ADDENDUM TO THE CONTRACT

Capital Transit Facility Renovation and Addition Contract No. E16-016

ADDENDUM NO.: TWO

DATE ADDENDUM ISSUED: March 22, 2016

A201

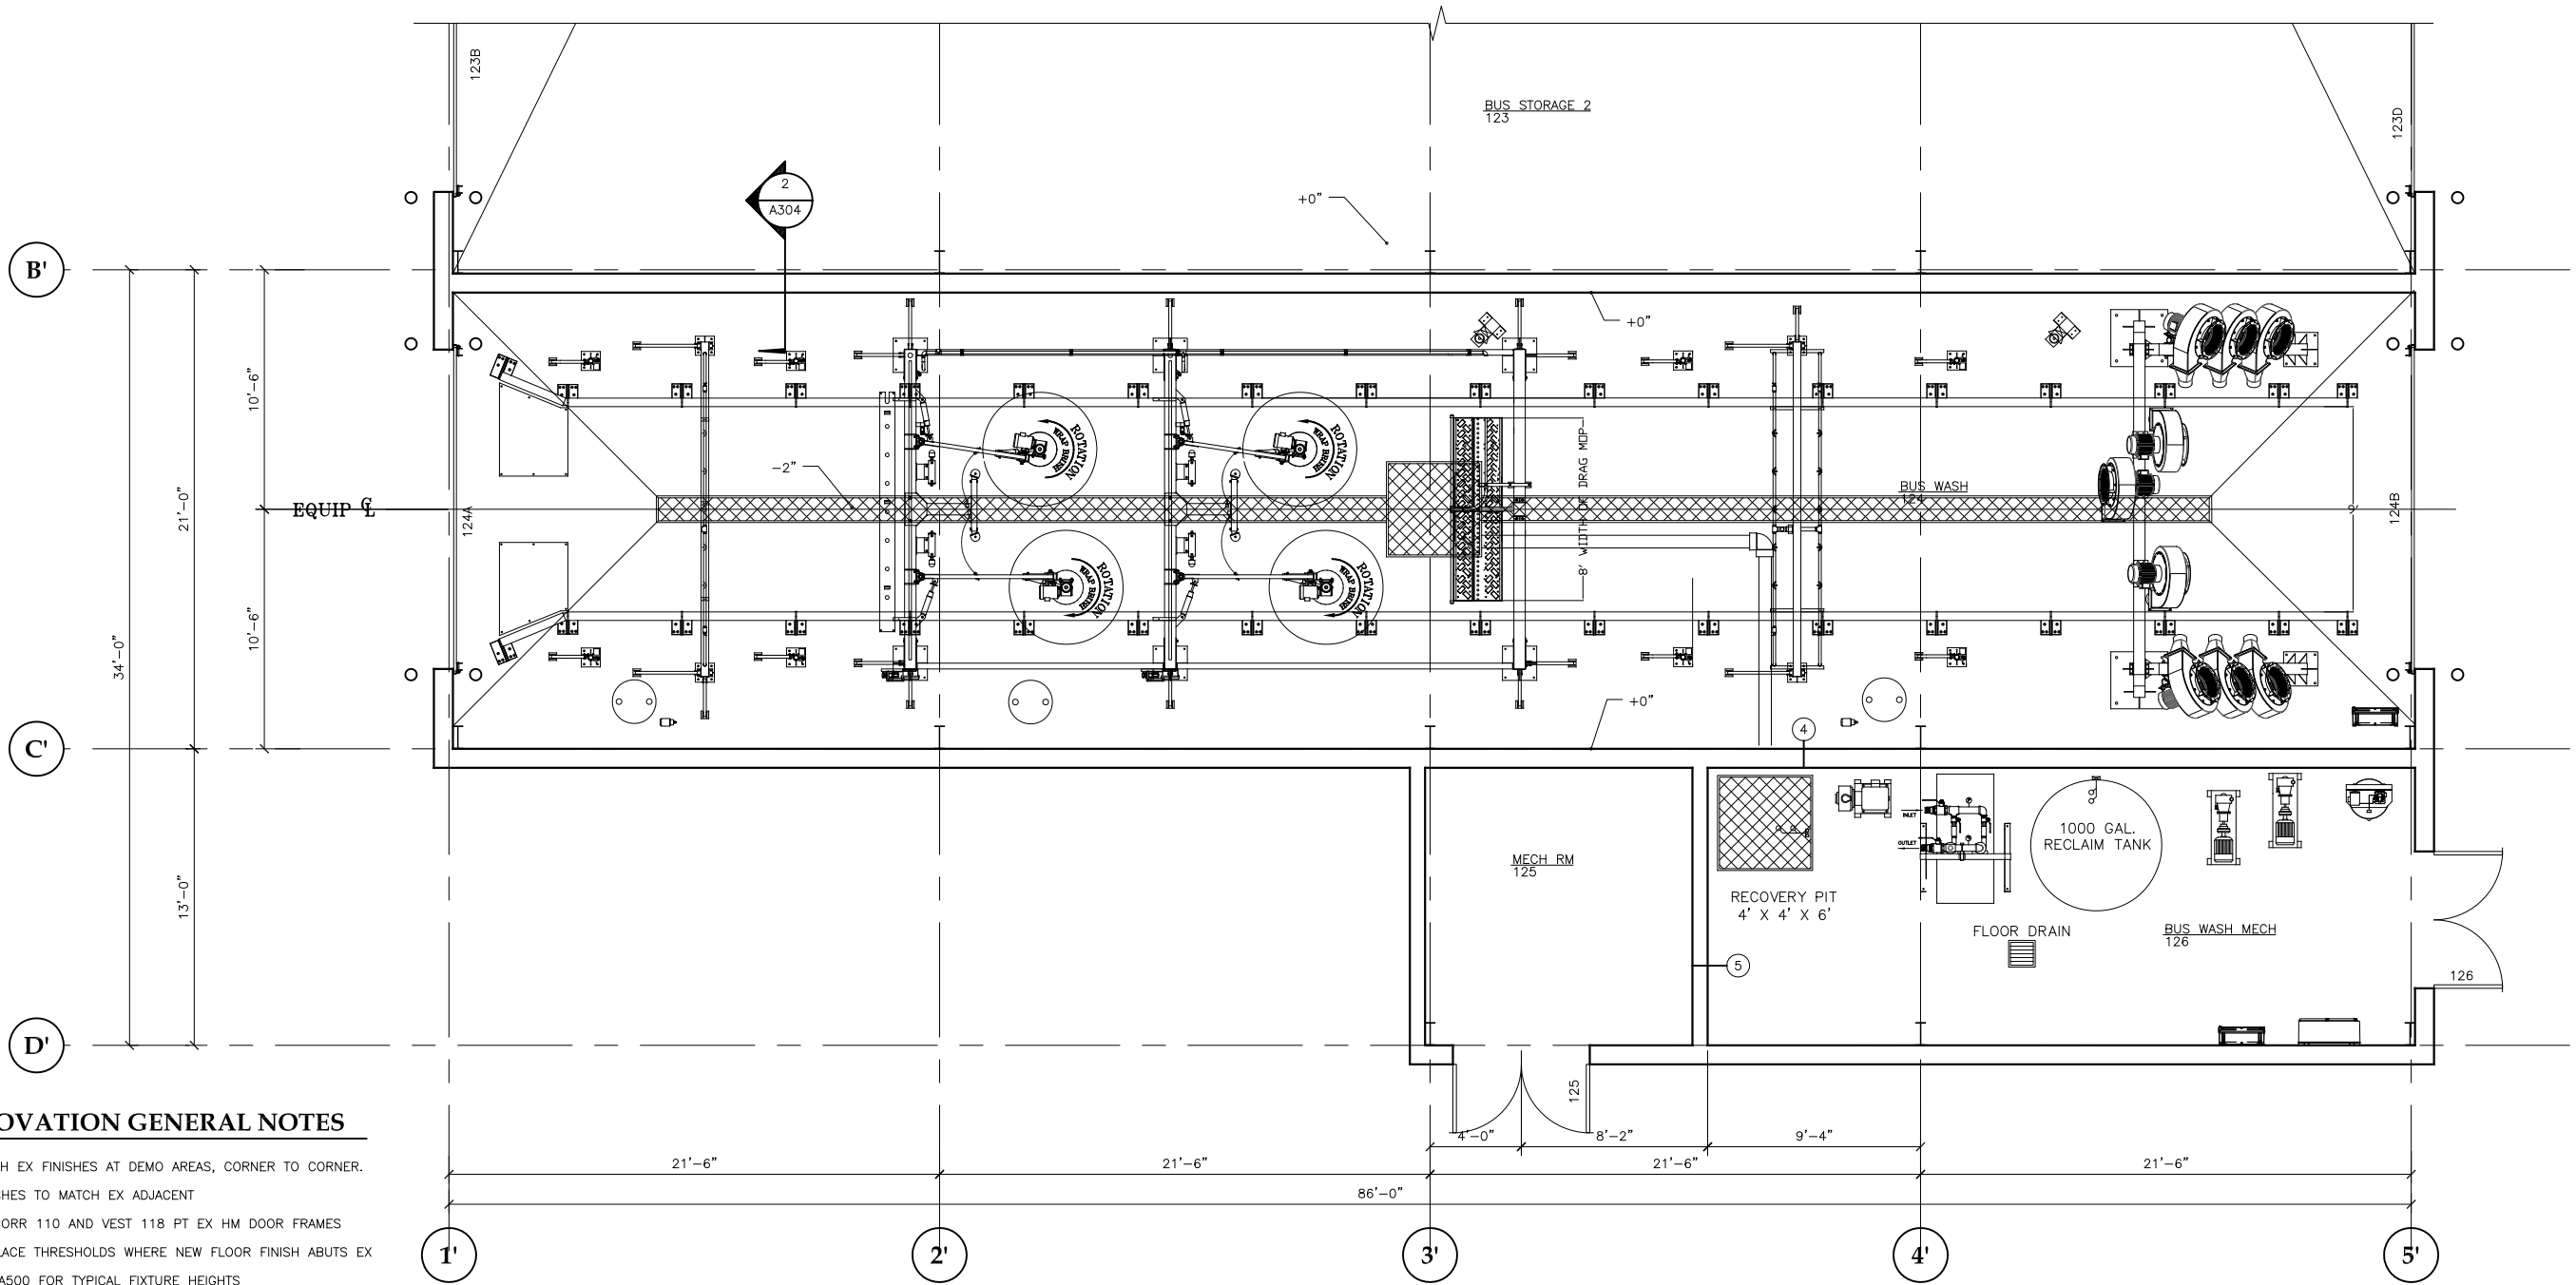
- Item No. 2 Sheet A201 OVERALL FIRST FLOOR PLAN, **Delete** and **replace** with the attached Sheet A201 OVERALL FIRST FLOOR PLAN, labeled Addendum No. 2, dated March 2016.

A403

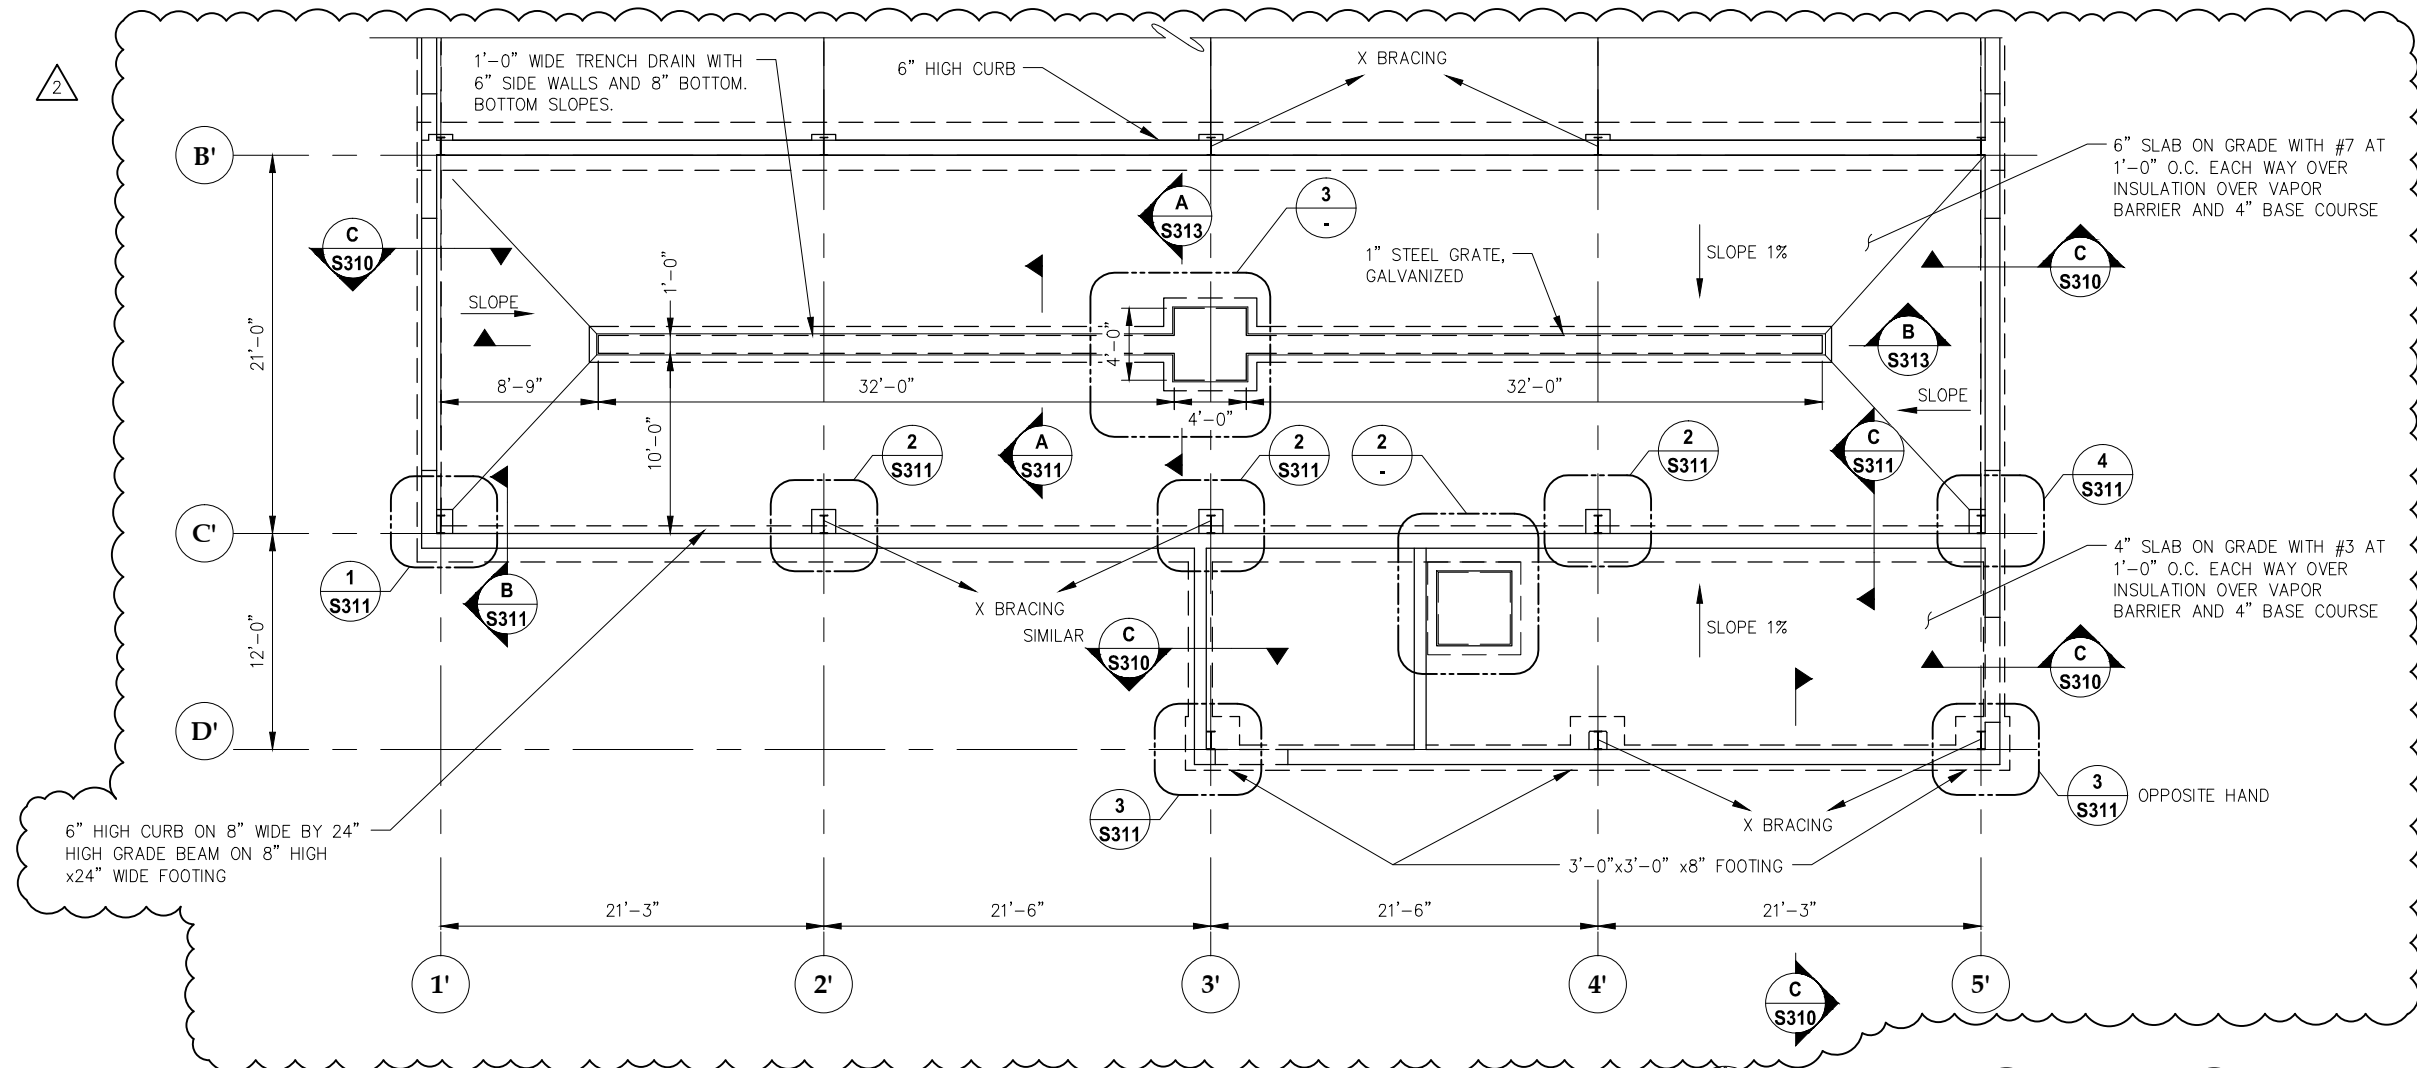
- Item No. 3 Sheet A403 ENLARGED FLOOR PLAN, **Delete** and **replace** with the attached Sheet A403 ENLARGED FLOOR PLAN, labeled Addendum No. 2, dated March 2016.

1 PARTIAL FOUNDATION PLAN BUS WASH SCALE: 0 2' 4' 8' 16'

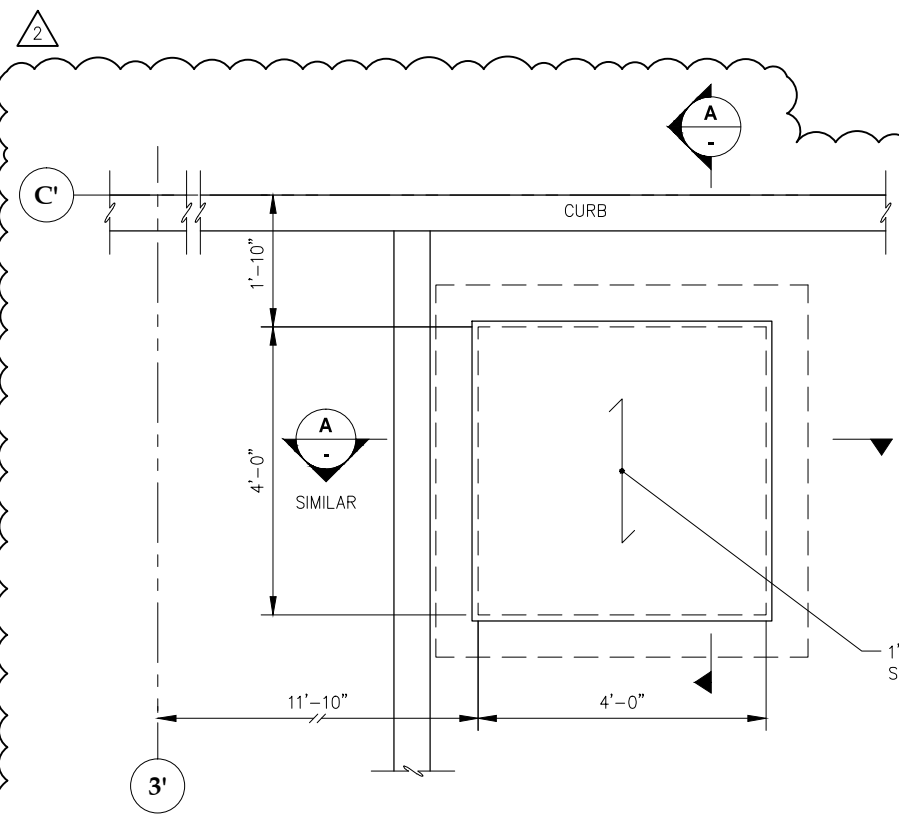
- Item No. 11 Sheet S211 PARTIAL FOUNDATION PLAN, **Delete** and **replace** with the attached Sheet S211 PARTIAL FOUNDATION PLAN, Revision 2, labeled Addendum No. 2, dated February 2016.

A BUS WASH TRENCH SECTION SCALE: 0 6" 1' 2'

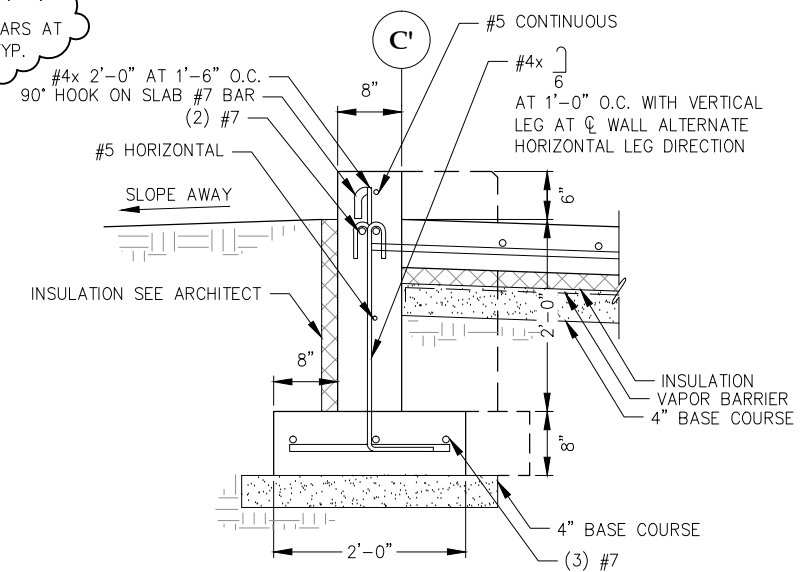
- Item No. 12 Sheet S311 BUS WASH FOUNDATION DETAILS, **Delete** and **replace** with the attached Sheet S311 BUS WASH FOUNDATION DETAILS, with Revision 2 for Detail A, labeled Addendum No. 2, dated February 2016.
